### Ohio Department of Transportation Response to Public Comment: Working Position Paper: Redesign of the Brent Spence Bridge Project

# Response to Public Comment Working Position Paper: Redesign of the Brent Spence Bridge Project

FROM: HNTB Corporation

RE: Brent Spence Bridge Corridor Project | ODOT PID 89068 | KYTC Project Item No. 6-17

### Figure 1: Modified Alternative B

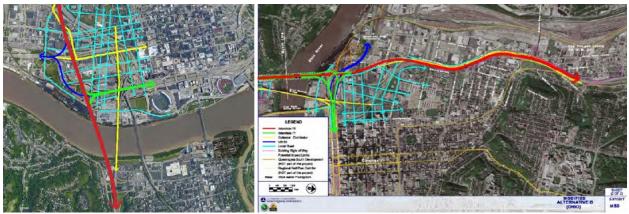
The *Position Paper* presents a modification to Alternative B from the 2009 *Conceptual Alternatives Study* (CAS) prepared for the BSB Corridor Project (see Figure 1). The CAS concluded that Alternative B resulted in adverse impacts to communities, residences, businesses, regulated materials sites, and utilities, which were substantially higher than other alternatives under consideration. In addition, Alternative B had substantially greater overall complexity, constructability risk, and cost when compared to other alternatives. Finally, the concept was strongly opposed by both the City of Cincinnati, Ohio and the City of Covington, Kentucky. Therefore, it was removed from further consideration.

Alternative B was developed based on extensive traffic operational analyses that established the traffic movements required to maintain local connectivity and acceptable traffic flow through the project area. In addition, ramp layouts – including high speed interstate to interstate connections between I-71 and I-75 – were established based on extensive geometric analysis. This alternative was developed to minimize impacts, therefore there are limited (if any) opportunities to "scale back and right-size<sup>1</sup>" Alternative B further such that the overriding negative impacts that led to its dismissal would be reversed.

### Figure 2: Modified Concept 85

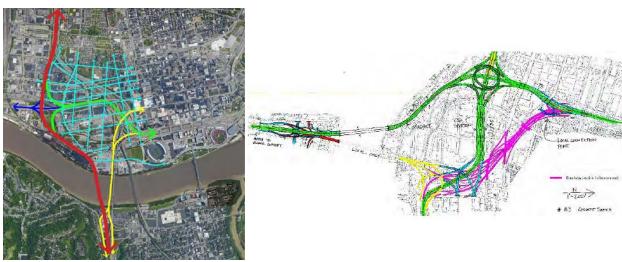
The *Position Paper* also presents a modification to Concept 85, which was developed during a Value Engineering Workshop for the BSB Corridor Project in October 2012 (see Figure 2). The *Position Paper* states that "Concept 85 was not advanced further, likely because the [project] team did not feel they had the license to pursue a project requiring relatively more right-of-way acquisition<sup>2</sup>." However, the project team evaluated Concept 85 and removed it from further study due to a number of factors, including:

• Additional impacts to parks and/or historic resources;

- City of Cincinnati opposition to reducing east-west connectivity and alternatives that shift I-75 to the west<sup>3</sup>;
- Impacts to United Parcel Service (UPS) in Ohio; and
- Engineering concerns related to a new bridge that crosses the Ohio river on a skew.

Given the above, the modifications to Concept 85 presented in the *Position Paper* – recessing the eastwest connection between US 50 and Fort Washington Way – would not address the factors for which it was removed from further study.

### Figure 3: The Boland Concept

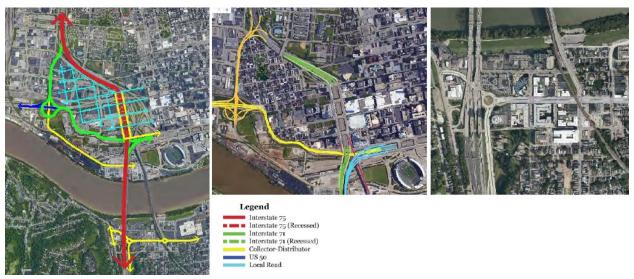
The final concept presented in the *Position Paper* was originally developed by Brian Boland (the Boland Concept). The Boland Concept (see Figure 3) depresses I-75 with parallel frontage roads similar to the layout of I-71 just east of the project area, which is locally known as Fort Washington Way. The Boland Concept also relocates I-71 and US 50 by carrying them across the BSB corridor and creating a new connection with I-75 to the north via Freeman Avenue. Finally, it reconfigures local roadways in Covington, Kentucky. The following sections discuss the geometric and traffic operational feasibility of the Boland Concept.

To meet these geometric constraints, the preferred alternative for the BSB Corridor Project currently descends toward downtown Cincinnati at a 4- to 5.5-percent grade. Depressing the roadway any further as presented in the Boland Concept would require substantially steeper roadway grades (up to 7.7 percent). For reference, ODOT's *Location and Design Manual, Volume 1* lists the maximum grade for urban interstates in similar terrain as 6 percent. Furthermore, given the complicated geometry, any changes to the mainline profile would cascade throughout the BSB interchange area, resulting in prohibitively steep grades along other ramps and C-D roads. Introducing grades of this magnitude would require design exceptions and present traffic operational and safety concerns, particularly considering the high volumes of heavy truck traffic traveling through the corridor. This would be contrary to the project's approved purpose and need, which includes improving traffic flow and safety and correcting geometric deficiencies through a key regional and national transportation corridor.

The geometric constraints in the corridor also affect local cross streets in the Boland Concept. Because the I-75 mainline and access ramps cannot be depressed further, local Cincinnati cross streets must be raised substantially to pass over I-75. In addition, 6<sup>th</sup> Street must be raised substantially to connect to eastbound US 50. These changes would require grades ranging from 5 to 9 percent on 4<sup>th</sup> Street, 5<sup>th</sup> Street, and 6<sup>th</sup> Street<sup>4</sup> (see Figure 4 and Attachment 2). ODOT's *Location and Design Manual, Volume 1* lists the maximum grade for urban arterial roadways as 7 percent. However, the manual states that maximum design grades should be used infrequently, rather than a value to be used in most cases. Grades of this magnitude are not only undesirable for vehicular traffic, but they also present substantial mobility and accessibility concerns for cyclists and pedestrians. The Americans with Disabilities Act (ADA) requires facilities that accommodate pedestrians to be constructed with grades of 5 percent or less.

The Boland Concept includes parallel frontage roads that intersect the local street network in a grid configuration (see Figure 3). However, the *Position Paper* did not include a traffic analysis to determine the number of lanes required for the frontage road system to operate. A high-level screening of traffic operations was conducted using available traffic data to determine the minimum number of lanes required to provide acceptable levels of service<sup>5</sup> for the frontage road intersections. Based on the screening, the frontage roads would require three to four lanes for through traffic with additional left and right turn lanes at each intersection to eliminate any adverse operations on the freeway system. The local cross streets would also require additional lanes for turning traffic. The minimum lanes required for the parallel frontage roads are depicted schematically in Figure 4.

Figure 4: Schematic Depiction of Boland Concept at Frontage Road Intersections

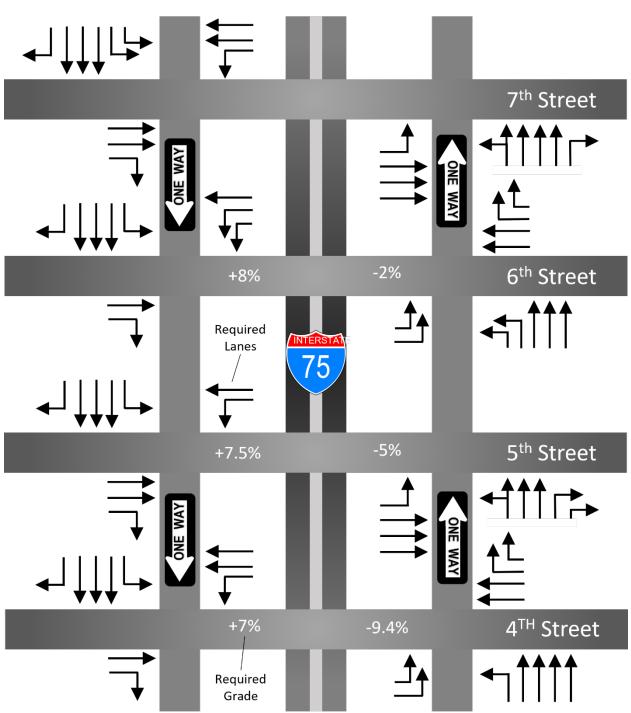
The BSB Corridor Project must serve both long-distance interstate traffic and local trips. When compared to the preferred alternative for the project, the Boland Concept eliminates a C-D system that serves local movements. As a result, traffic traveling between Covington and downtown Cincinnati would be required to utilize other congested cross-river routes and the signalized frontage road intersections, resulting in longer travel times and increased congestion on local streets.

Attachment 1: BSB Corridor Project Tiered Bridge System

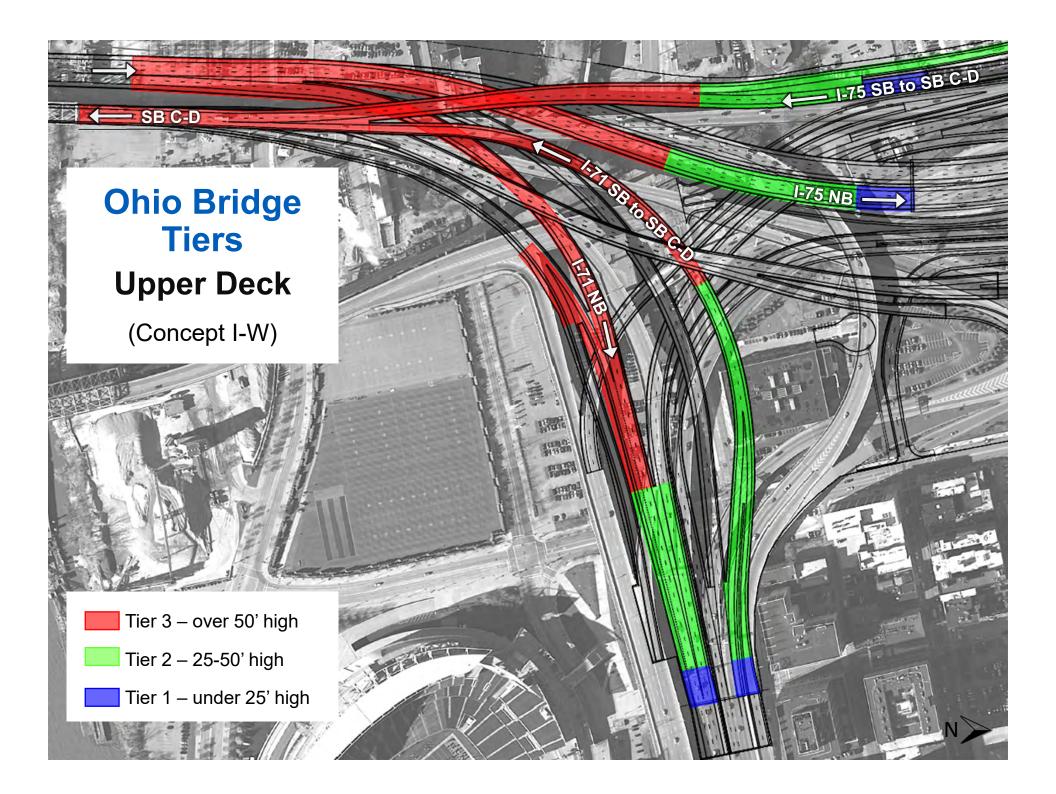
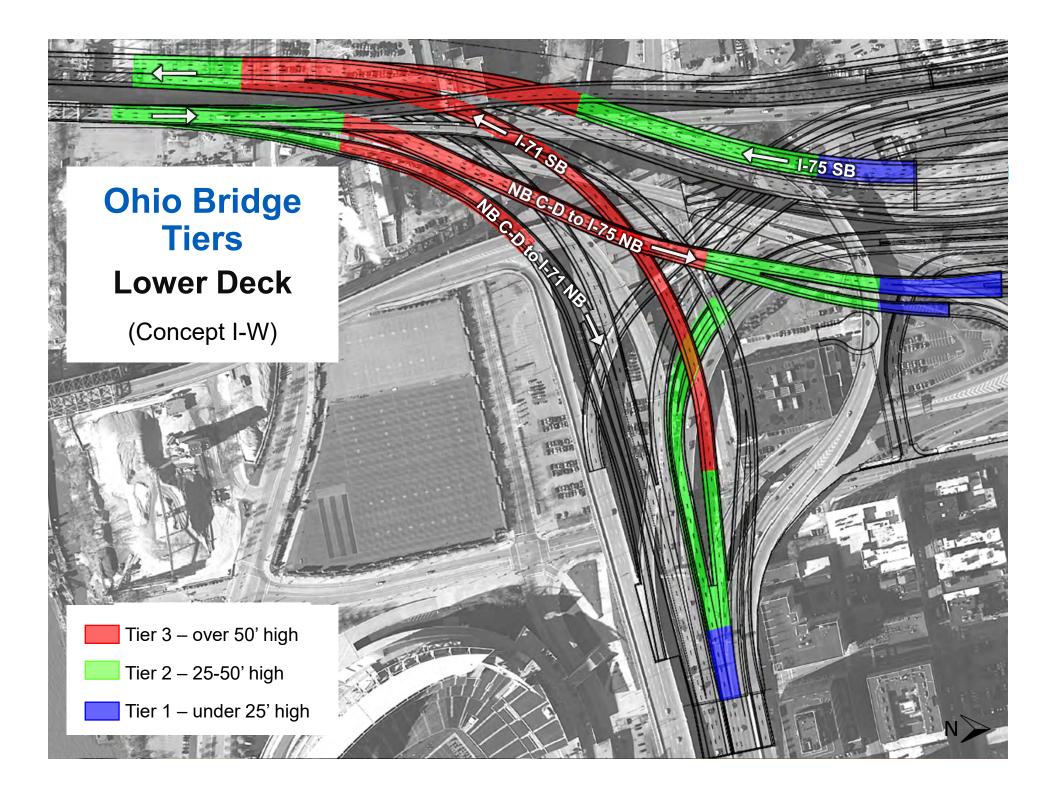
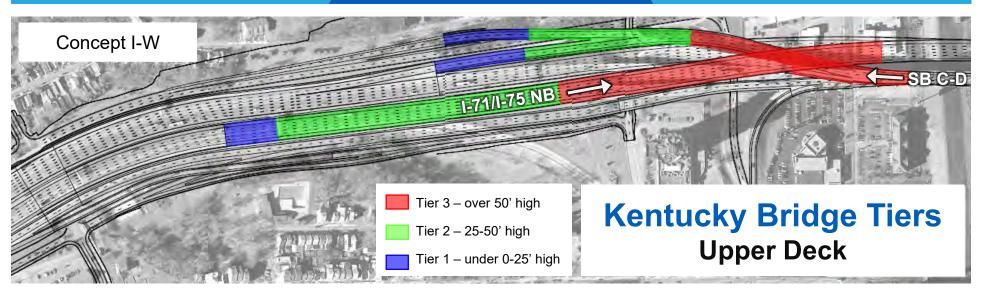
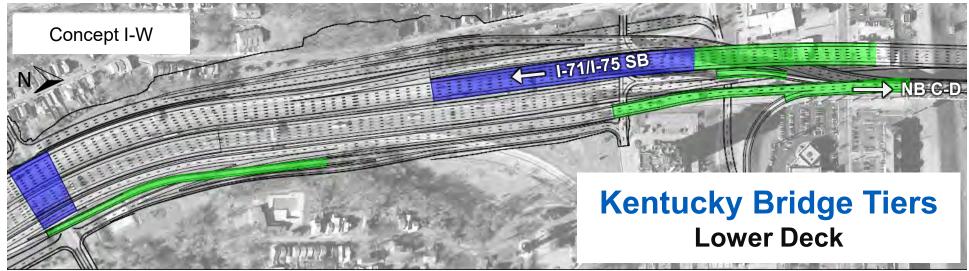
- Any bridge over the Ohio River must meet U.S. Coast Guard clearance requirements, which means the bottom of the bridge will need to be 55 feet above the flowline of the Ohio River.
- Once the interstate passes over the Ohio River, it cannot descend directly into downtown Cincinnati. First, it must stay elevated to cross active CSX rail lines between Pete Rose Avenue and 3rd Street.
- Any design must accommodate a complicated system of mainline and ramp movements to provide local access and continuity along I-71, I-75, and US 50. Weaving these ramps through the project area requires a complex tiered bridge system with the highest tier rising over 50 feet above the ground (see Attachment 1).
